Groundwater Application Review Summary Form

Application # G- 19243

GW Reviewer Grayson Fish Date Review Completed: 9/27/2023

TO: Water Rights Section Date 9/27/2023
 FROM: Groundwater Section Grayson Fish
 Reviewer's Name
 SUBJECT: Application G- 19243 Supersedes review of _____
 Date of Review(s)

KLAM 53717 Hydrograph

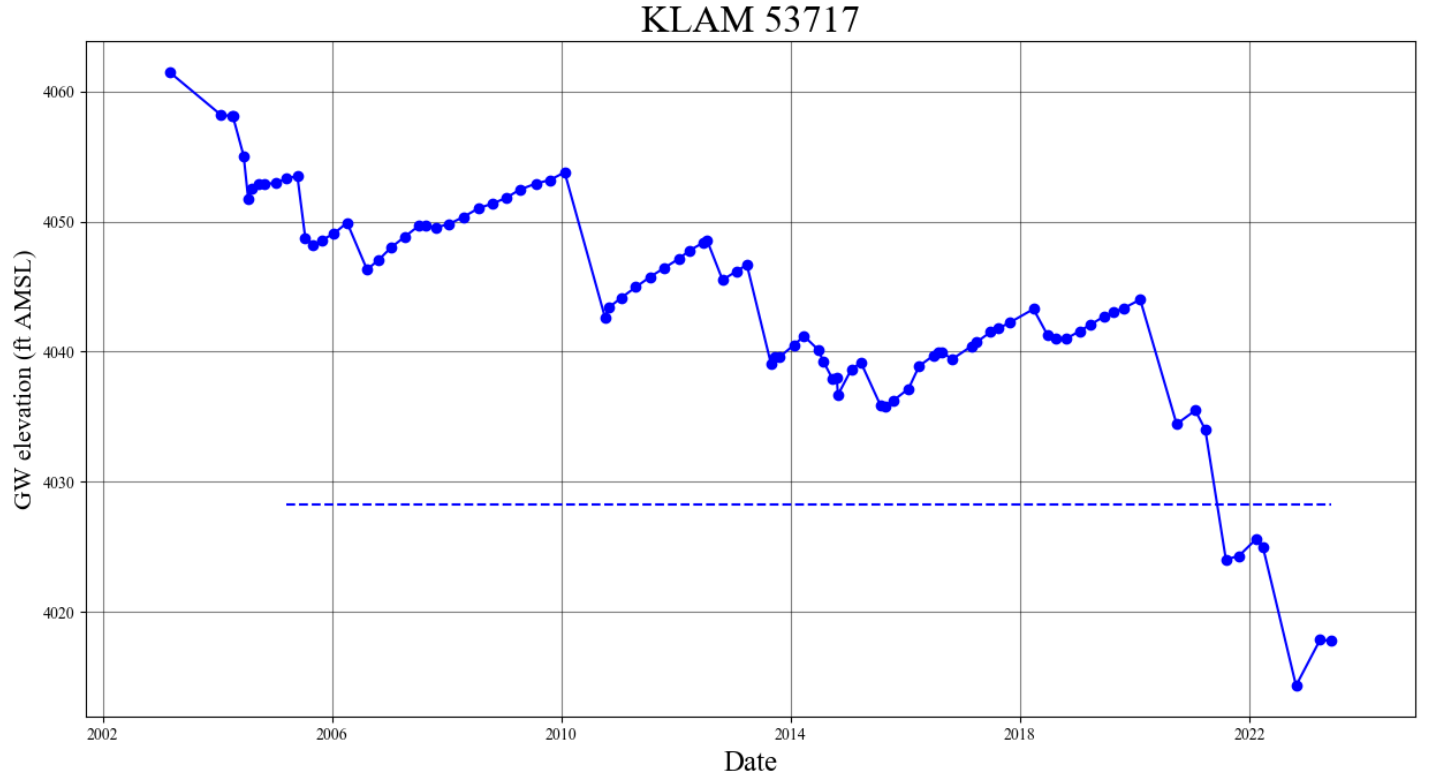
The applicant’s proposed POA is located within the Bureau of Reclamation’s Klamath Project area of the Upper Klamath Basin. Wells throughout this area have experienced long term-water level declines associated with increased groundwater pumping during drought years when Project surface water deliveries have been shut off or reduced. The nearby observation well **KLAM 53717** has experienced approximately 40 feet of groundwater level declines since measurements began in 2004, with 26.15 feet of decline observed between 2020 and 2023 when comparing annual high-water levels. These year-over-year declines associated with drought years and annual highs that do not recover to previous levels suggest that groundwater storage in the area is being depleted. Given the rate of decline observed during the drought years of 2020, 2021 and 2022, and the expected rate of recovery during non-drought years, it is likely **KLAM 53717** would exhibit a total groundwater level decline of 50 feet or more from the highest known water level (meeting the definition of “declined excessively” per OAR 690-008-001 [4]) within the next one or two drought years. Additionally, **KLAM 53717** has triggered the 25 feet of total

decline permit condition on Certificate 96331 which requires the discontinuation or reduction of water use until groundwater levels recover above the Certificate's reference level. If proposed groundwater use were to commence as described in this application, it would further contribute to observed groundwater level declines in this portion of the basin and potentially lead to declined excessively groundwater levels and additional permit decline conditions triggering on existing rights. This would preclude the perpetual use of the aquifer by limiting the use of existing water right holders and, therefore, groundwater for the proposed use will not likely be available within the capacity of the resource.

Theis Drawdown

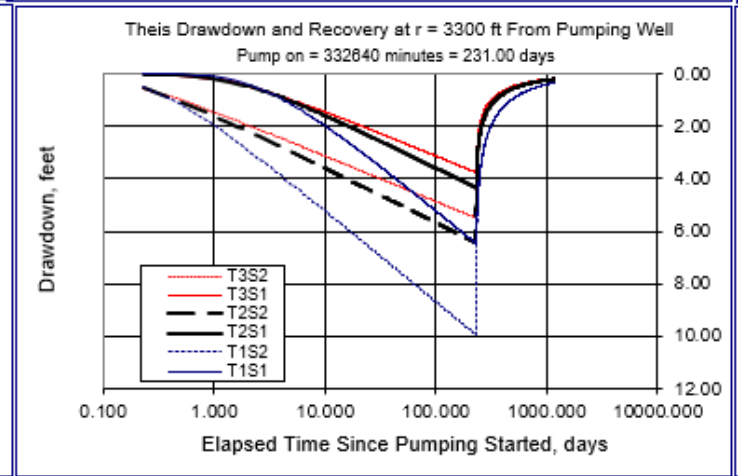
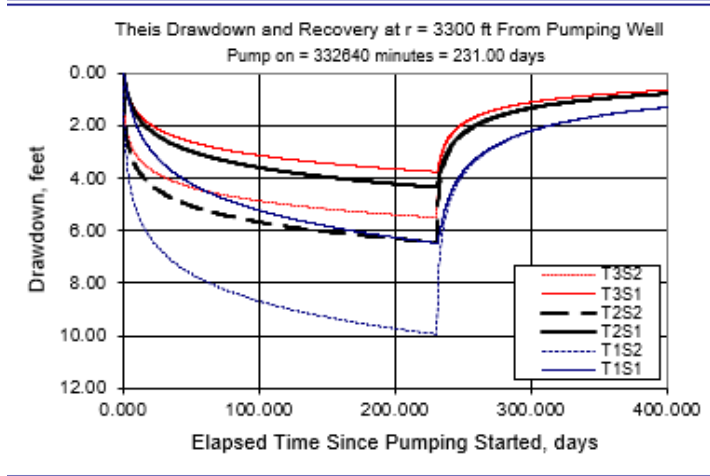
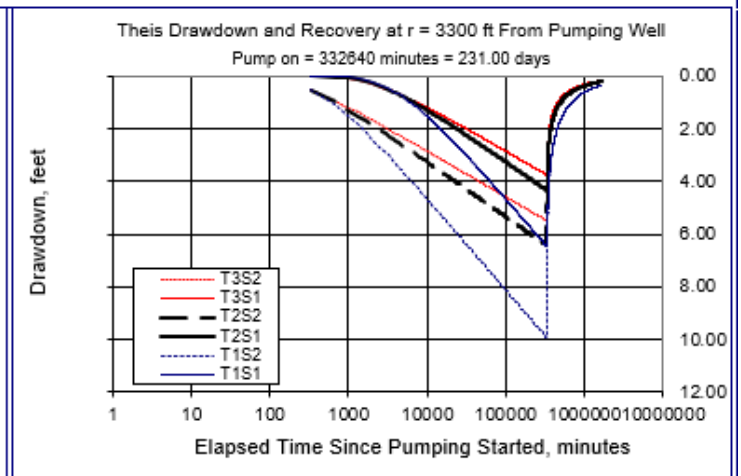
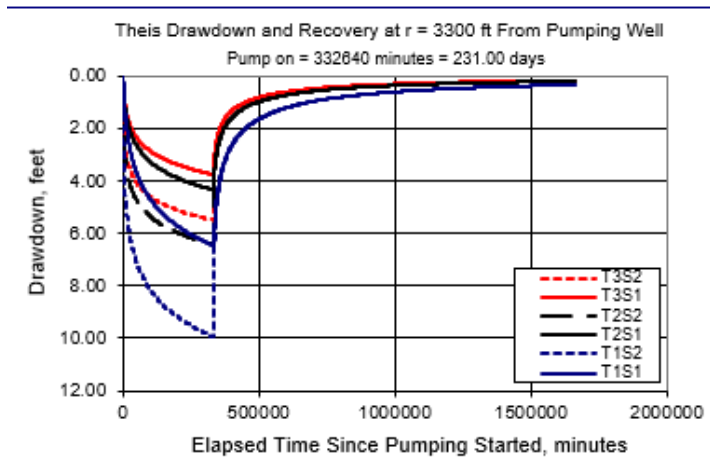
The closest POA for a senior water right is **KLAM 53717** under **Certificate 96331** with a priority date of 2003 located 0.6 miles to the northeast of the proposed POA **KLAM 61328**. The applicant has requested a rate of 7.54 cfs from one well to water 603.54 acres at a duty of 2.5 af/ac. However, it is unlikely that the applicant would pump at the maximum requested rate for the entirety of the irrigation season as their maximum volume of 1508.85 AF (603.54 ac multiplied by a duty of 2.5 af/ac) would be achieved in 101 days. Therefore, a prorated rate 3.30 cfs for 231 days is considered to be a more realistic use case and is the rate used for evaluating the potential for injury. A Theis distance drawdown model along with bulk aquifer transmissivity and storativity values (Gannett et. al, 2007) was used to estimate the magnitude of well-to-well interference that may result from the proposed use (Theis 1935). Results indicate that the proposed use could produce 4 to 10 feet of drawdown in senior point of appropriation **KLAM 53717**, however, given the well depth and the estimated amount of water column available to the senior POA, there is not a preponderance of evidence to determine that injury is likely to occur. If this water right were to be issued, permit conditions should be applied as reference in B1(d)(i) of this review form.

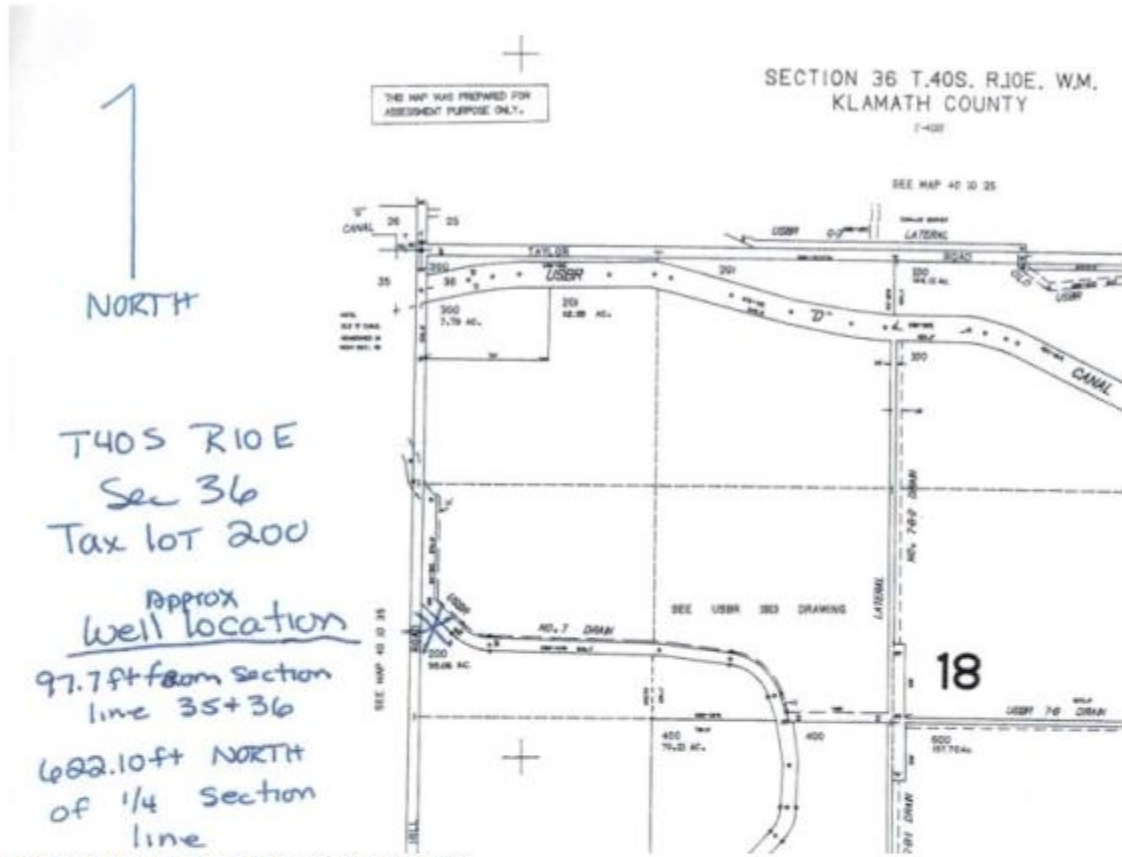
I am starting my groundwater review of Water Right application [G-19243 \(state.or.us\)](#) and noticed that there was a discrepancy with the location of the provided well log (KLAM 53717) and the application map (attached). Our database indicates that [KLAM 53717 \(state.or.us\)](#) is located northeast of the location provided on the application map (Location of KLAM 53717 circled in red, location provided on the application map in blue):

The location on the provided application map appears to correlate to KLAM 61328 (well report attached with a site figure). Was KLAM 61328 the intended proposed POA for application G-19243?

As we discussed, you indicated the intended proposed point of appropriation (POA) is **KLAM 61328** (well report attached) as marked on the application map. I will include this email on the groundwater review form as a record of our discussion. A caseworker may reach out to you in the future for any application amendments that are required.
